# Access Compliance Report

## Public Rights-of-Way

### (Curb Ramps)

Intersection ID: 26278	Main Street: BEVINGTON_PL	Cross Street: WESTBURY_WOODS_DR	Location: SE
ADA ID: 1B5B74A89139	Ramp Type: PerpDiag	Initial Pass/Fail: Fail	Overall Compliance: No
		Severity Score: 12.5

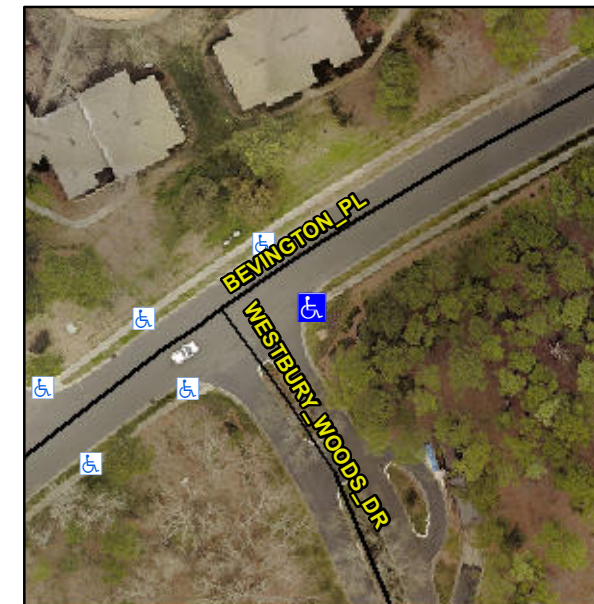
**Not Found, R304.5.3**

Compliance	Description	Data	Compliance	Description	Data
N/A	Ramp Length (in)	60.0	Yes	Ramp Slope (%)	7.9
Yes	Ramp Width (in)	48.0	No	Ramp XSlope (%)	5.7
N/A	Flare Type LT	N/A	N/A	Flare Type RT	N/A
N/A	Flare Slope LT (%)	N/A	N/A	Flare Slope RT (%)	N/A
N/A	Flare Traversable LT?	N/A	N/A	Flare Traversable RT?	N/A
N/A	Landing Length (in)	N/A	N/A	DWS Provided?	N/A
N/A	Landing Width (in)	N/A	N/A	DWS Contrast?	N/A
N/A	Landing Slope (%)	N/A	N/A	DWS Length (in)	N/A
N/A	Landing X Slope (%)	N/A	N/A	DWS Full Width?	N/A
N/A	Landing Curb? (Y/N)	N/A	N/A	DWS Offset (in)	N/A
N/A	Shared Landing?	N/A			
N/A	Gutter Ponding?	N/A	N/A	Gutter Slope (%)	N/A
N/A	Gutter Lip Ht (in)	N/A	N/A	Gutter X Slope (%)	N/A
N/A	Painted X Walk1?	No	N/A	Painted X Walk2?	No
	X Walk 1 Direction	To N		X Walk 2 Direction	To SW
N/A	X Walk 1 Width (in)	N/A	N/A	X Walk 2 Width (in)	N/A
	X Walk 1 Slope (%)	2.5		X Walk 2 Slope (%)	2.1
	X Walk 1 X Slope (%)	1.1		X Walk 2 X Slope (%)	6.9

**Remove & Replace Curb Ramp With Two New Directional Ramps or Equivalent.**
